Field Modification FM22007

VS2.5 (3 PS): Replacing UG69* and NAPS43* with UG132 and NAPS58A

Issue 1.0 11 January 2023

FIELD MODIFICATION

Figure 1: VS2.5 Top View with NAPS53 and UG69s

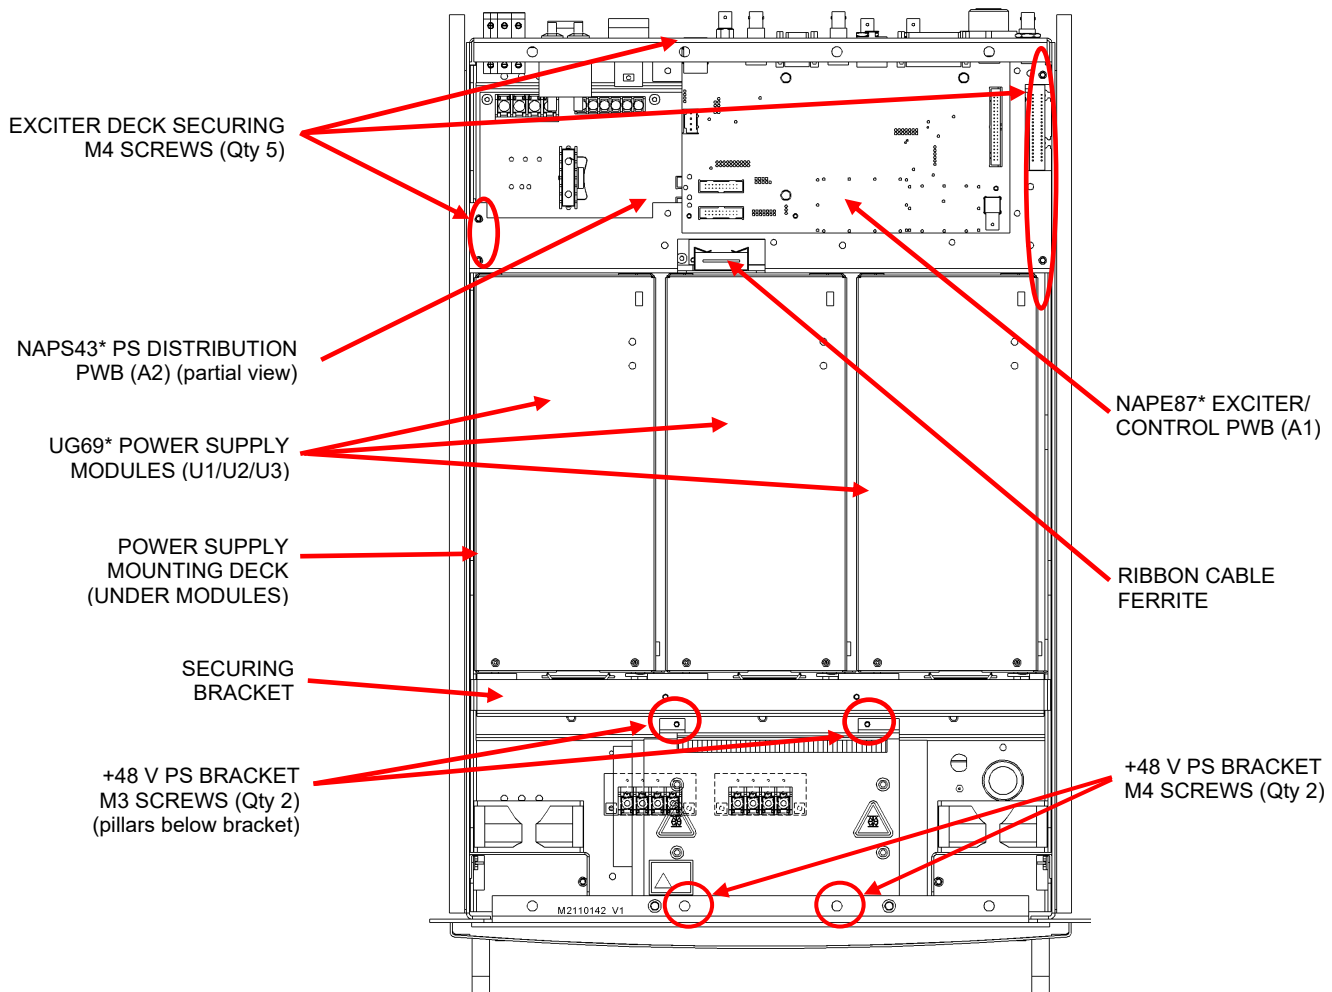
- (a) Remove the VS2.5's top cover and retain hardware.
- (b) Remove the securing bracket from the front of the Power Supply Modules (U1 to U3) by removing the two (2) M3 screws in the top of the bracket (see Figure 1) and the two (2) M4 countersunk screws in each side of the transmitter chassis. Discard bracket and retain hardware.
- (c) Slide the Power Supply Modules toward the front of the transmitter to disengage them from their mating connectors.
- (d) Remove the Power Supply Modules from the transmitter. If desired, retain any functional Power Supply Modules as spares for other transmitters that use UG69* modules. Discard defective Power Supply Modules as per local electronics waste management policies (if applicable).

- (f) Remove and retain the five M4 screws that secure the Exciter Deck (see Figure 1).
- (g) Before removing the Exciter Deck, ensure that the exciter wiring and associated items are clear of the Power Supply Distribution PWB and Exciter Deck, cutting tyraps if necessary. Cut the tyrap around the Ribbon Cable Ferrite (see Figure 1) to move the ribbon cables clear of the Exciter Deck and be careful in the following step not to damage the ferrite. Cut the adhesive tape that secures the Ribbon Cable Ferrite bracket to the Exciter Deck. Retain the adhesive tape for re-installation.

Figure 2: Orientation of Installed Items – Exploded View

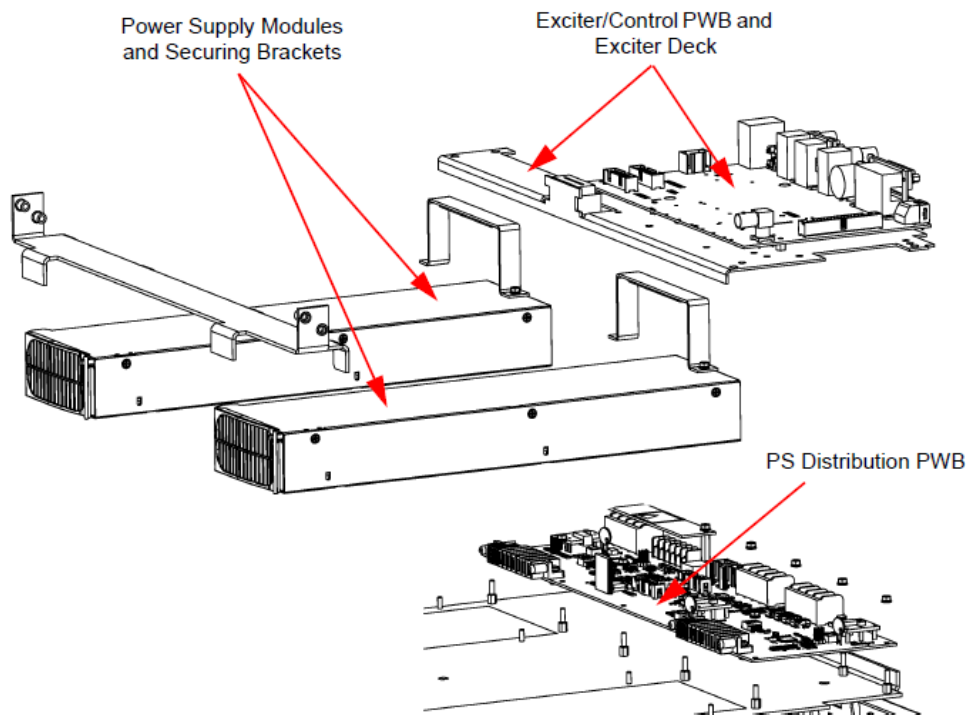
Refer to Figures 2, 3 and the attached Mechanical Drawing MD-4 for reference.

- (d) Install the Power Supply Distribution PWB on its 11 mounting pillars (see Figures 2 and 3). Use hardware retained in step 2.2 (d) to secure the PWB (not all hardware is reused), using a 5.5-mm nut driver for nine M3 nuts, split and flat washers, and a 6-mm nut driver for two pillars near TB1 and TB2.

Figure 3: New Power Supply Mounting Deck

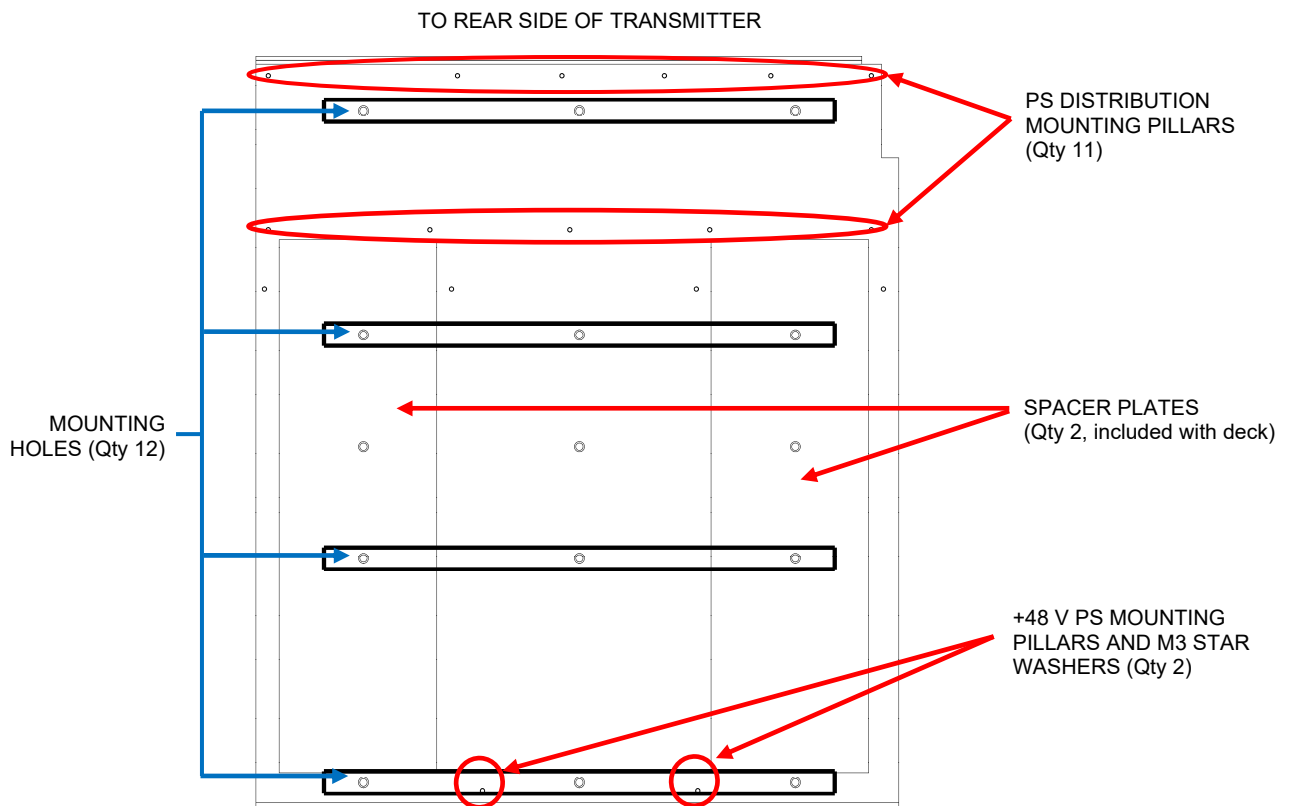
- (b) Install 11 of the 12 pillars and washers retained in step 2.2 (h) in the PS Distribution Mounting Pillars positions shown in Figure 3. Install the chafe rail on the rear side edge.

- (c) While ensuring that all wires removed in step 2.2 (c) are clear of the deck area, install the Power Supply Mounting Deck to the transmitter chassis using the 12 M3 countersunk screws retained in step 2.2 (e). See Figure 3 for mounting locations for both scenarios.

- (f) Connect the 17 wires (# 7 through 14 and 25 through 33) removed in step 2.2 (b) to terminal blocks TB1 through TB4 of the Power Supply Distribution PWB. Refer to Table 4.3, Wiring List – VS2.5 Transmitter of the Troubleshooting Manual for wiring details.
- Torque connections on TB1, TB3 and TB4 to 20 in-lbs (2.24 N-m).
 - Torque connections on TB2 to 6 in-lbs (0.67 N-m).
- (g) Re-install the cover over TB1 and TB2 using retained M3 screws.
- (h) Use a 6-mm nut driver to re-install the pillars retained in step 2.2 (g) on the Power Supply Mounting Deck, on top of new M3 star washers (Nautel Part # HMW10) from the Hardware Kit. See Figure 3 for +48 V Power Supply mounting pillar locations.

Figure 4: VS2.5 Top View with new PS Distribution PWB and Power Supply Modules

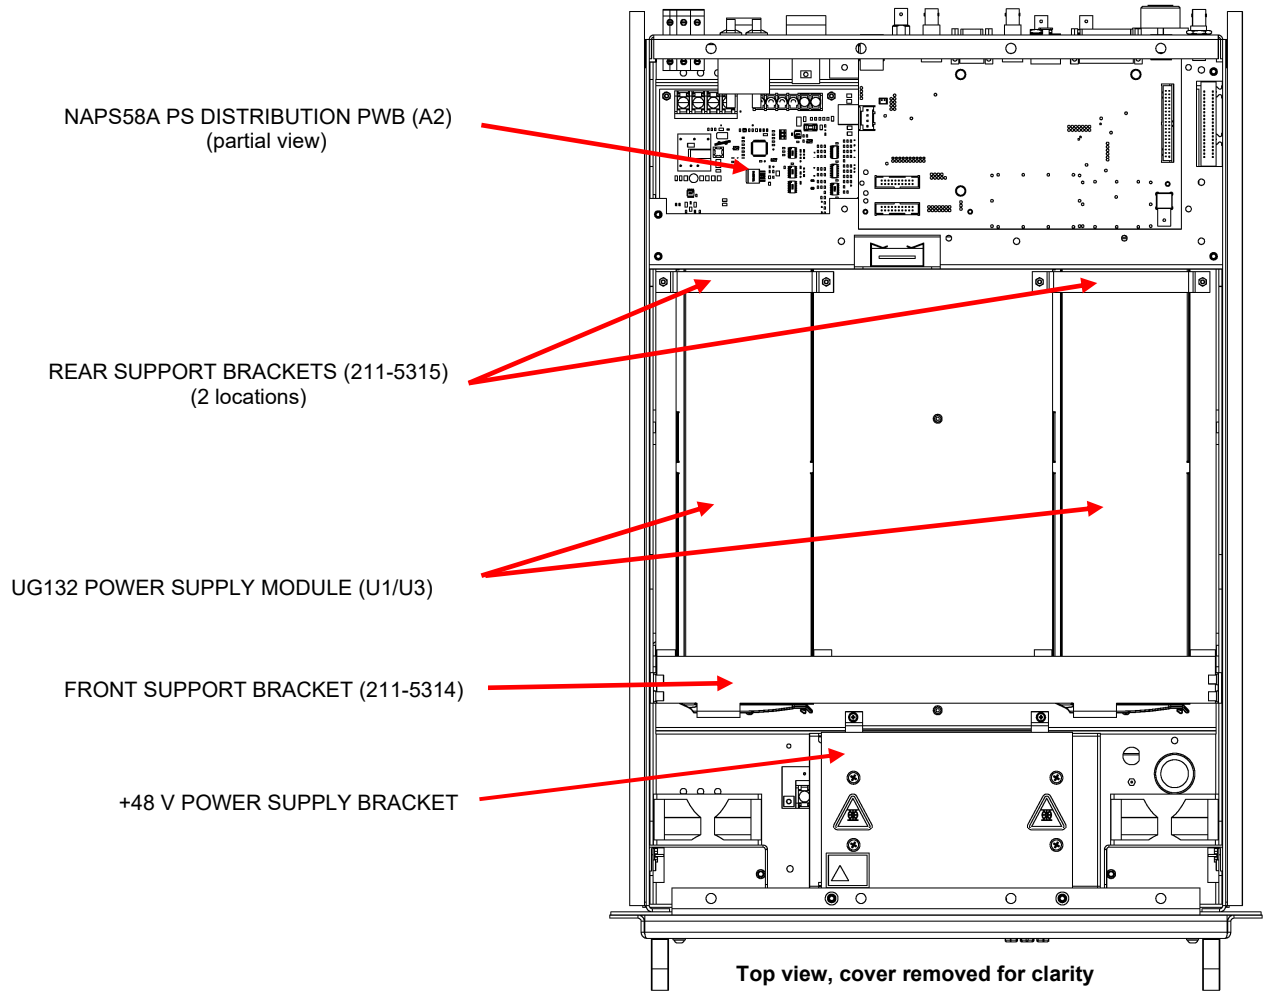
- (b) Install the new Power Supply Modules in the U1 and U3 positions of the transmitter (the middle position, U2, is no longer used) and slide them toward the rear of the transmitter to engage them with their mating connectors. The Power Supply Modules should be resting on their respective Spacer Plates (see Figure 3) when correctly positioned.
- (c) Install the Front Support Bracket on the front of the Power Supply Modules using the four M4 screws removed in Step 2.1 (b). The bracket is secured with two screws on each side of the transmitter. See Figure 4.
- (d) Install the two (2) Rear Support Brackets on the rear of the Power Supply Modules using the four (4) sets of M3 nuts and washers (Nautel Part #'s HMN02, HMW02 and HMW32), found in the Hardware Kit. See Figure 4.
